## ADDENDUM

**ADDENDUM NO.:** 04  
**PROJECT NAME:** Emiliano Zapata Academy Annex  
**PROJECT NO.:** 05055  
**CONTRACT NO.:** C1580  
**DATE OF ISSUE:** September 1, 2017

### NOTICE OF CHANGES, MODIFICATIONS, OR CLARIFICATIONS TO CONTRACT DOCUMENTS

DRAWING NO.  
**ES.1**

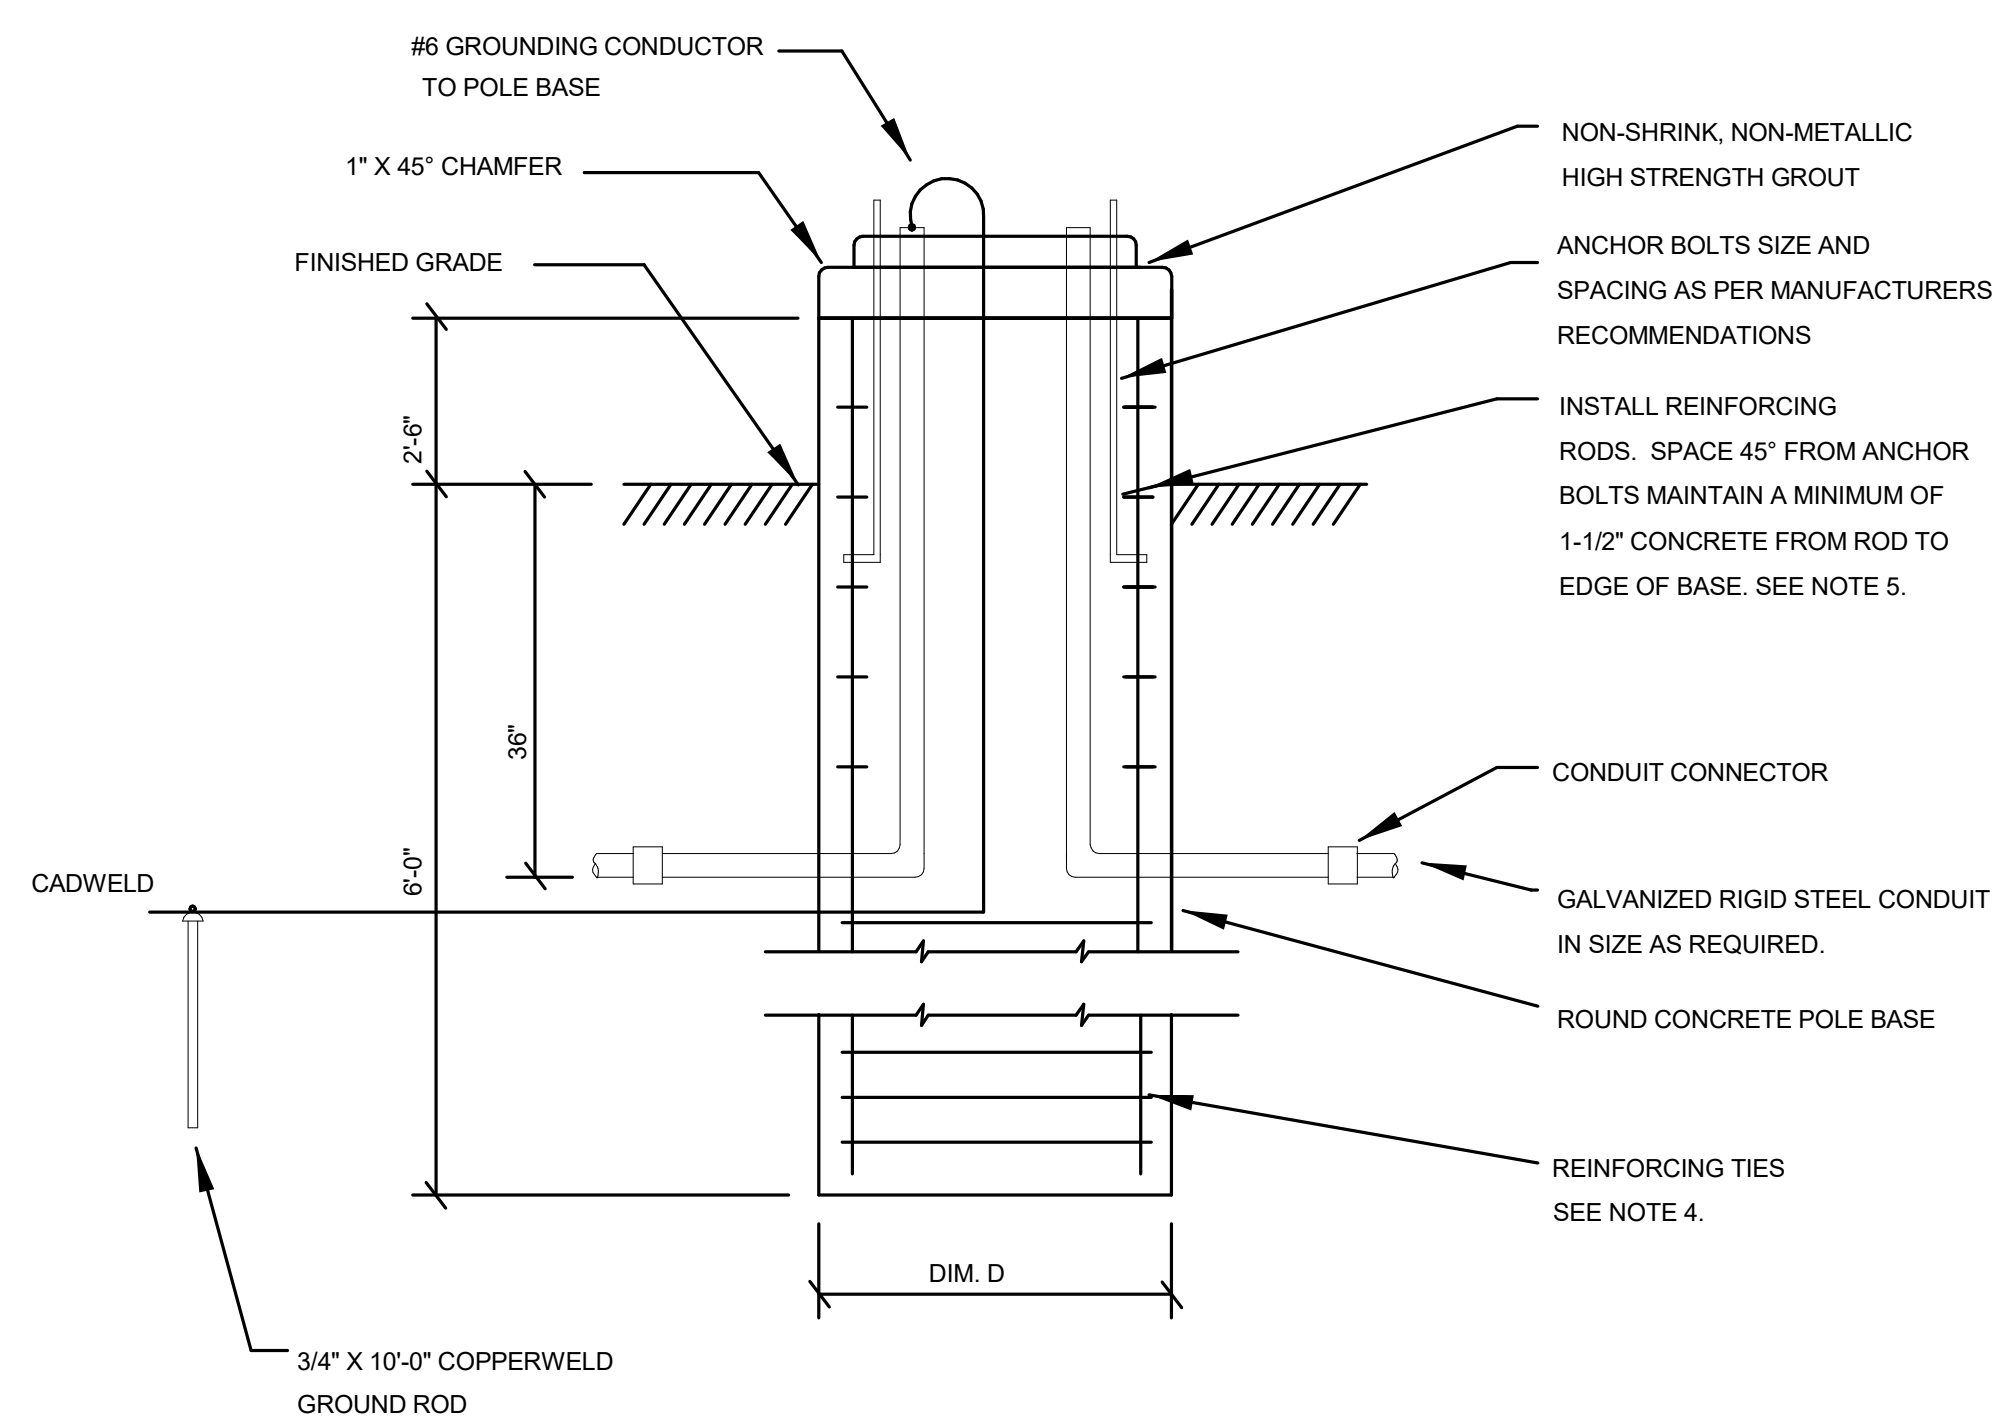
**Question:** A note was added to the Civil Site Utility Plan C4.0 in Addendum 2 calling for the telecom duct bank to be rerouted. The Electrical Site Plan ES.1 calls for this same telecom duct bank to remain and be protected during construction. Please confirm whether this duct bank is to be rerouted or to remain.
